Subject: Musik Express Aluminum Track

SERVICE BULLETIN

S.B. Number: 2001-02

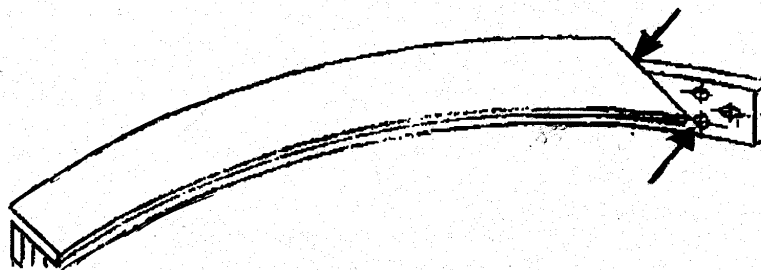
This bulletin pertains to the safe operation of your Musik Express. It has come to our attention that cracks have developed on the aluminum track where one track is bolted to the other.

The owner/operator must inspect the area around the singe bar (see diagram). If cracks are visible, they **MUST** be re-welded.
